Traffic Engineering RFI Response Letter

5 June 2025
Our Ref: 23BRT0507
Council Ref: COM/2024/317

Re: 202 Baileys Mountain Road, Upper Coomera – Request for Information Response

PROJECT NUMBER 23BRT0507	ORIGINAL SIZE A3
DRAWING NUMBER 23BRT0507-06	REVISION C
DATE 27 May 2025	SHEET 1 OF 1

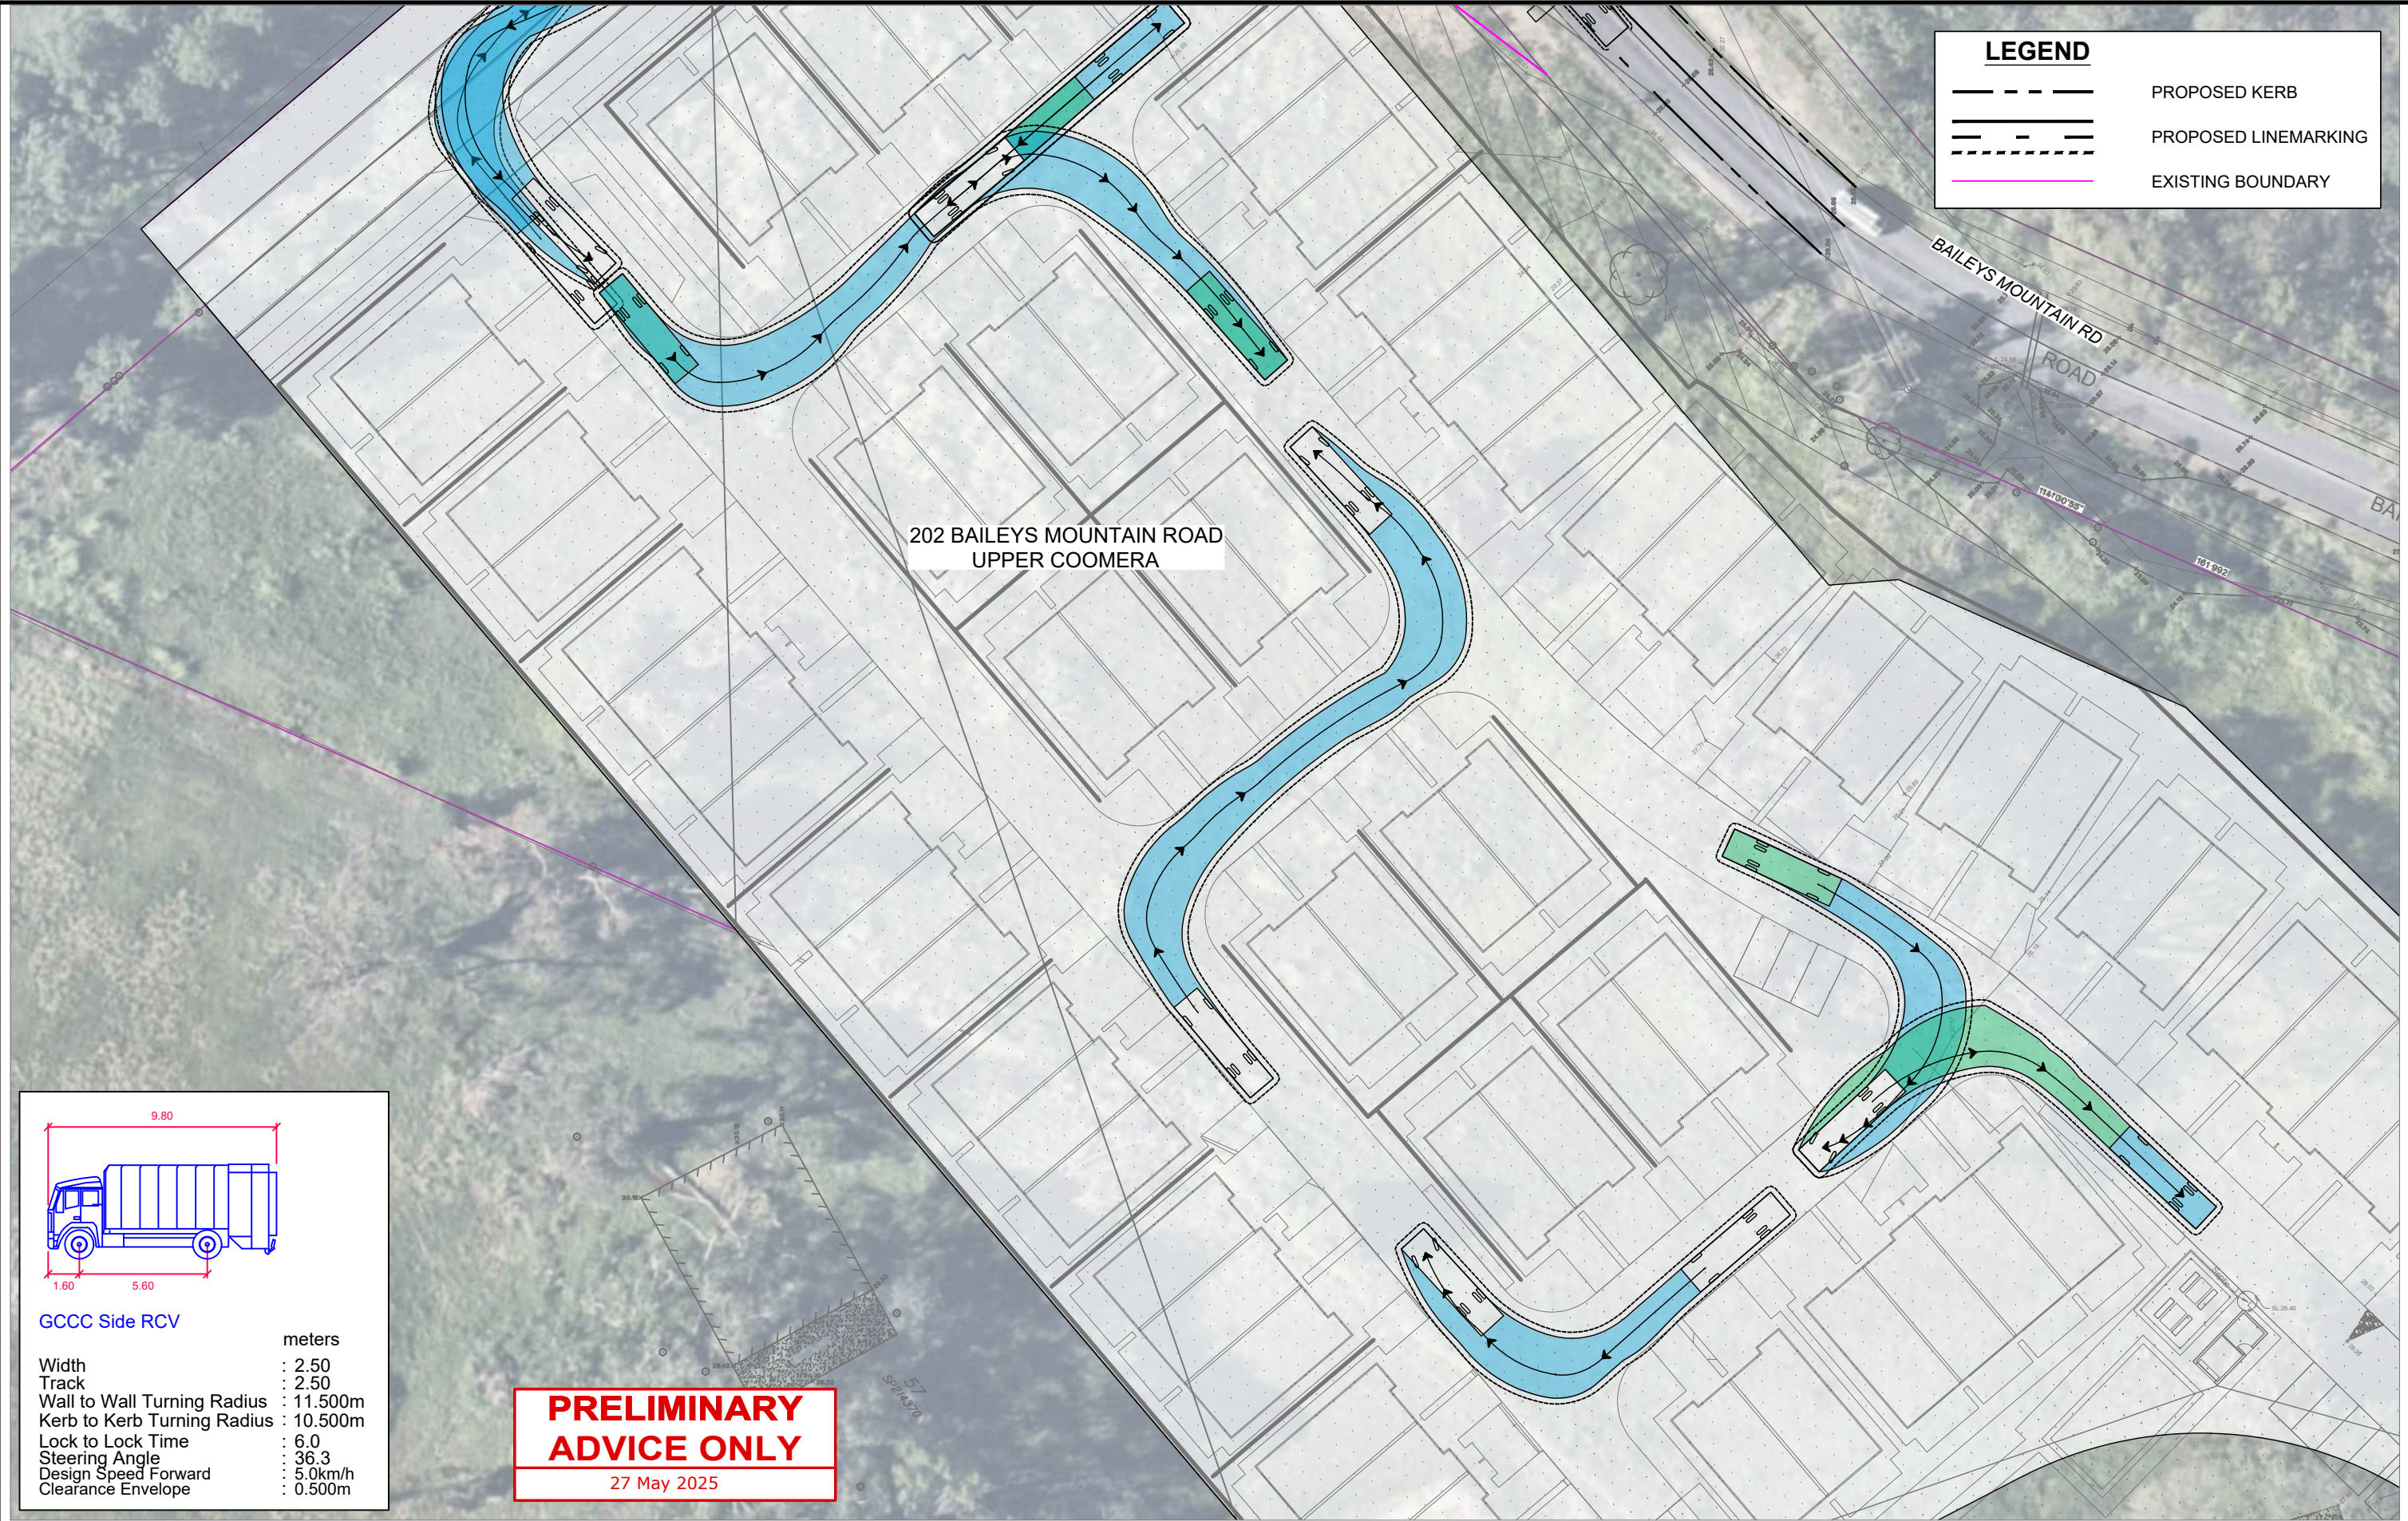
(a) *Swept path analysis is to be generated by AutoTurn, AutoTrack or similar.*

- (b)** *Plans must demonstrate vehicle specifications in accordance with the 'City Plan Policy – Solid Waste Management' including the kerb-to-kerb turning radius as nominated in Appendix C of SC6.16 City plan policy – solid waste management code.*

- (c)** *Manoeuvring clearances in accordance with AS2890.2 must be clearly depicted on drawings and demonstrate no obstructions exist for all waste servicing manoeuvres.*

- (d)** *Reversing movements on-site are to be kept to a minimum and access to the development from the road is to comply with AS2890.2.*

Colliers acknowledges Council's request for swept paths, which have been completed using AutoTURN. The updated swept paths indicate there is sufficient space for a CoGC side-loading refuse collection vehicle (RCV) to manoeuvre the site and pickup bins kerbside (see **Attachment B – 23BRT0507-06**).

In accordance with Council's 'City Plan Policy – Solid Waste Management,' vehicle specifications have been updated - including the kerb-to-kerb turning radius of 10.5m for the refuse vehicle (see **Attachment B – 23BRT0507-06**).

Colliers have ensured all swept paths have manoeuvring clearances of 500mm (either side) for service vehicles (including WCV), and 300mm (either side) for B99 vehicles. Colliers notes that "Appendix C – Waste Collection Vehicle Clearances" of Council's City Plan specifies a 300mm clearance either side to ensure safe access and unimpeded operation of service vehicles. The swept paths indicate that no obstructions exist for all waste servicing manoeuvres (see **Attachment B – 23BRT0507-06**).

There are two locations in the internal site layout where a reverse manoeuvre will be utilised to fulfil refuse collection duties of the WCV. At the majority of these locations, the WCV will not reverse more than 2 lengths; this is considered safe and the most efficient method of kerbside refuse collection. For the south-east location, a slightly longer reverse manoeuvre (3 vehicle lengths) is illustrated, which is considered acceptable in this

instance given the overall development layout and that there are no residential crossovers on the nearside of internal circulation road where the reverse manoeuvre occurs (see **Attachment B – 23BRT0507-06**).
